Engineering Operations
Building Addition

Contract: 6484
Project: 10308
Common Council Approval:
8/2/2015

Revisions by Addendum

No.	Description	Addendum
1	Re-issued and added notes for clarification	1

1 2nd Floor Garage - Mezzanine Framing Plan
3/32" = 1-0"

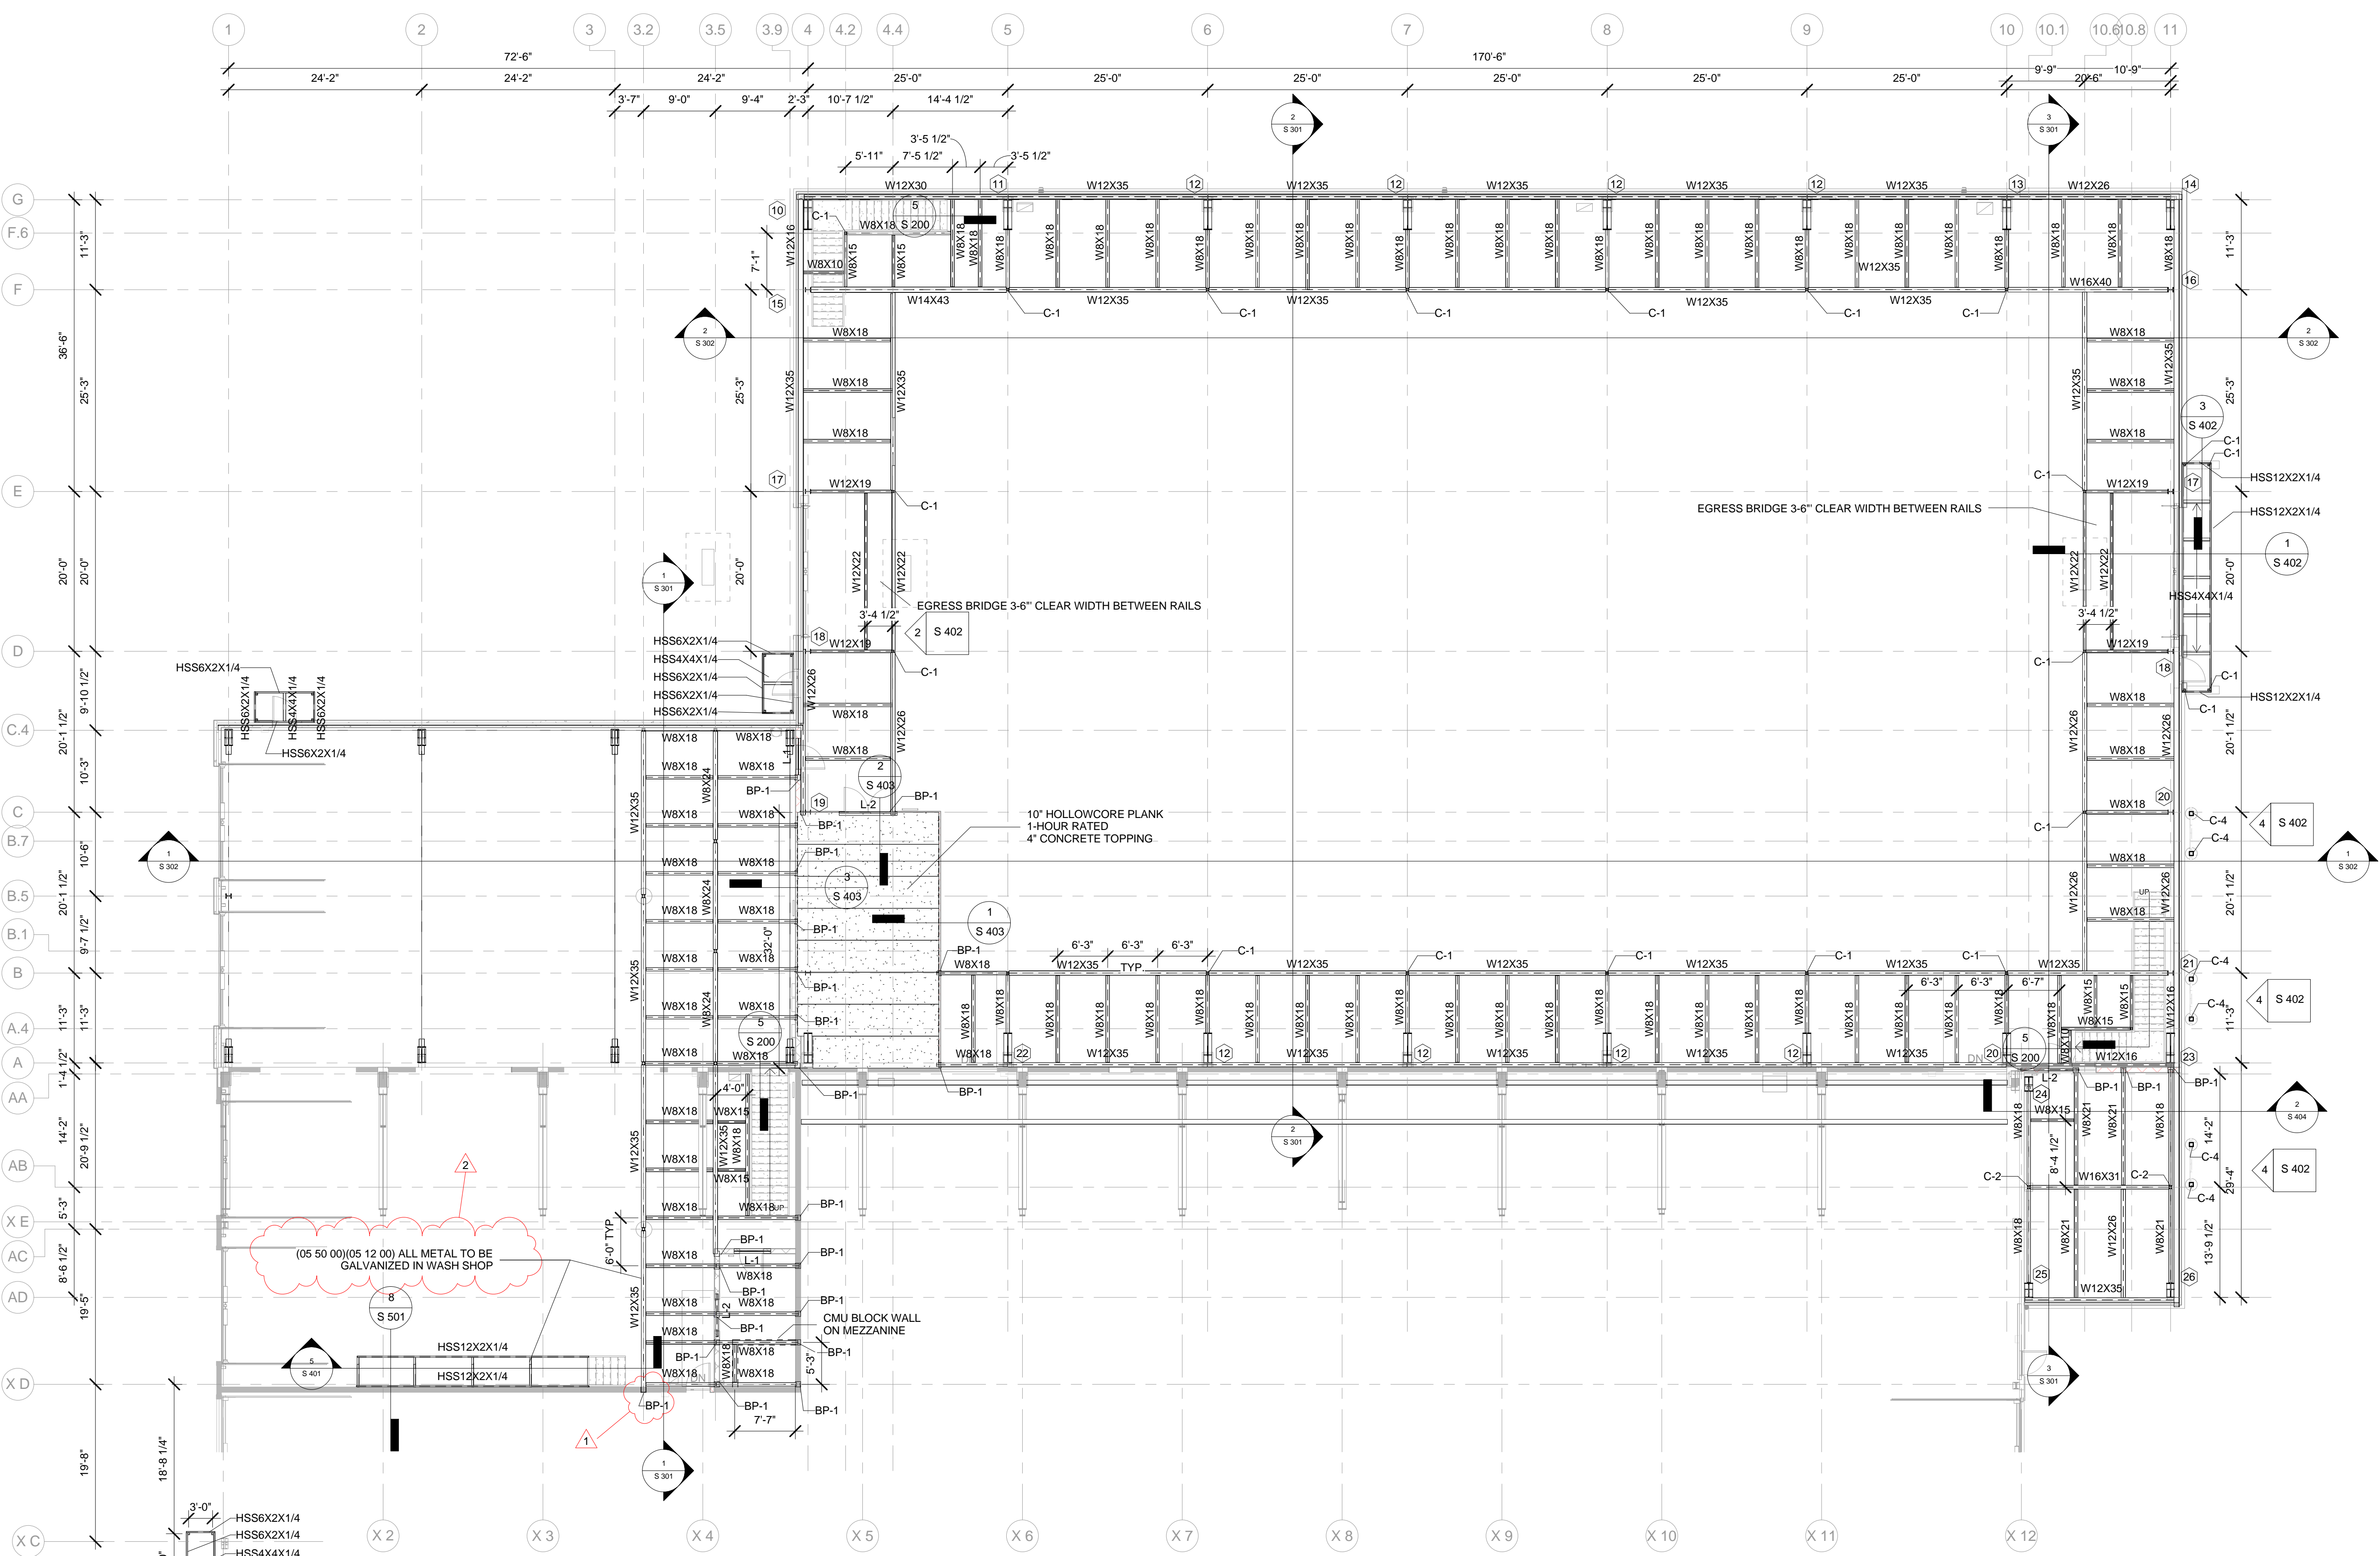
No.	Description	Addendum
1	Structural framing	1
2	Galvanized metal	1

(05 50 00)(05 12 00) ALL METAL TO BE GALVANIZED IN WASH SHOP

(05 50 00)(05 12 00) ALL METAL TO BE GALVANIZED IN WASH SHOP

1 Roof Framing Plan
3/32" = 1'-0"

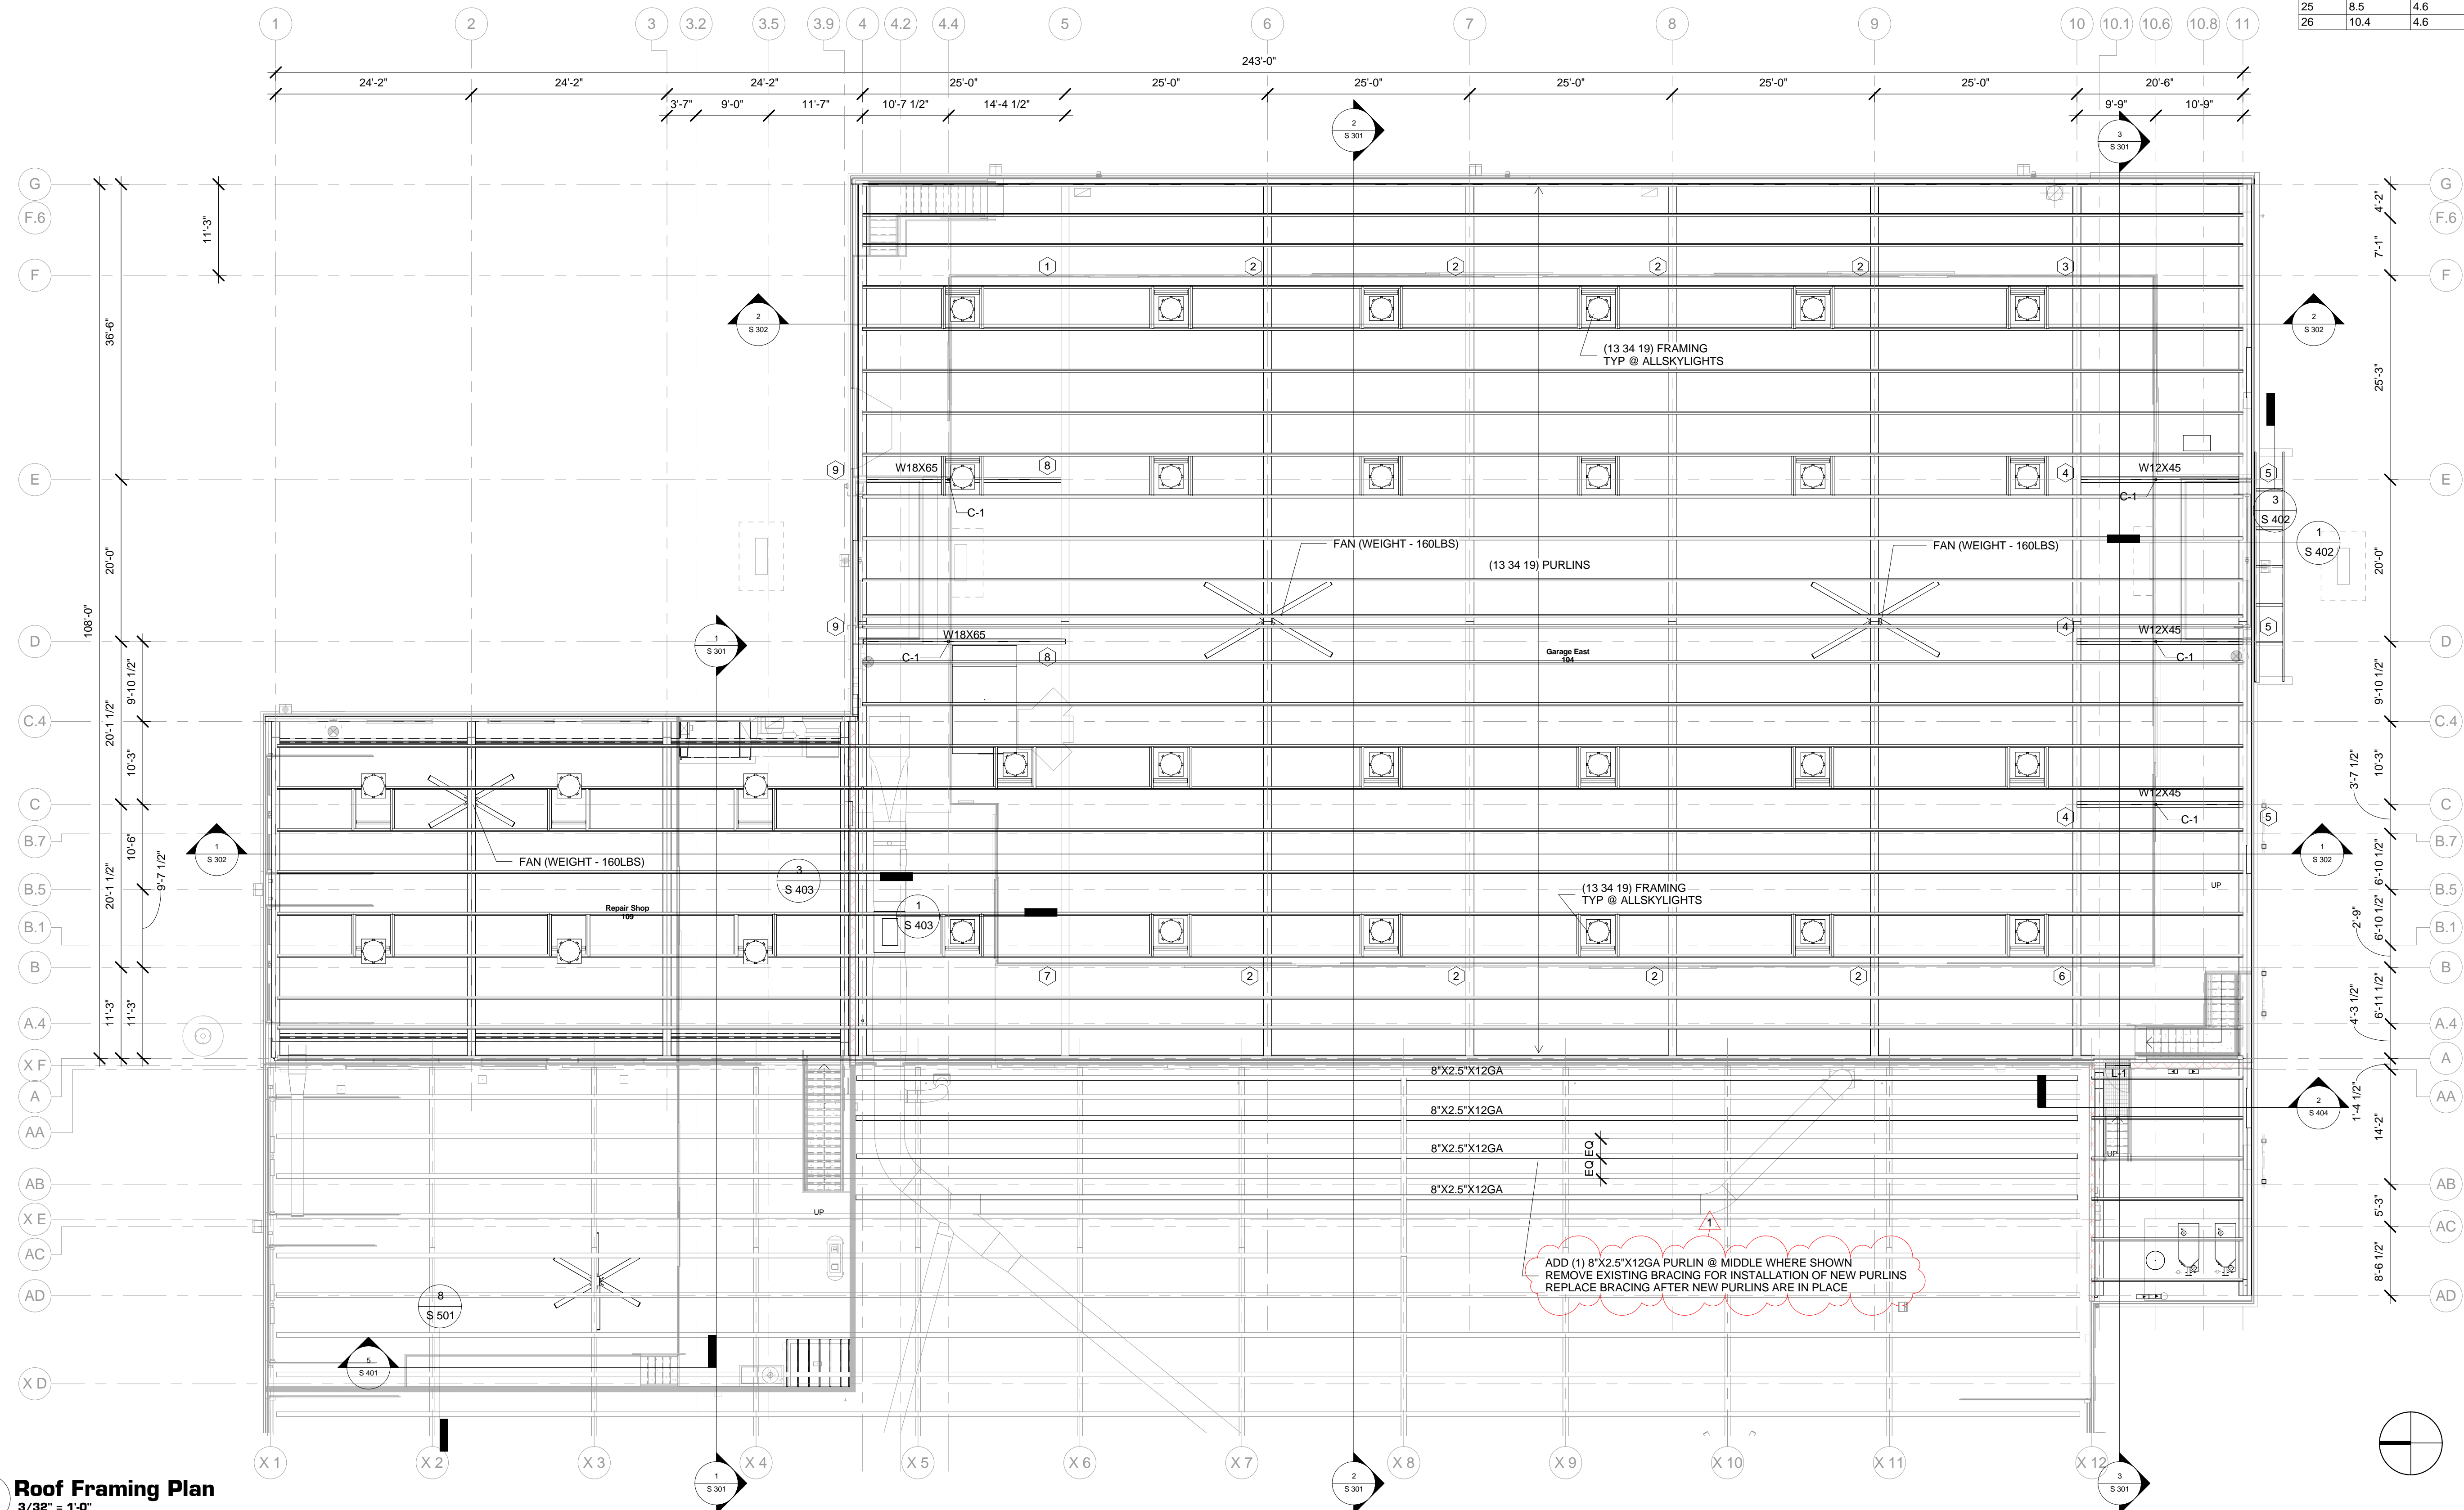
No.	Description	Addendum
1	Structural framing	1
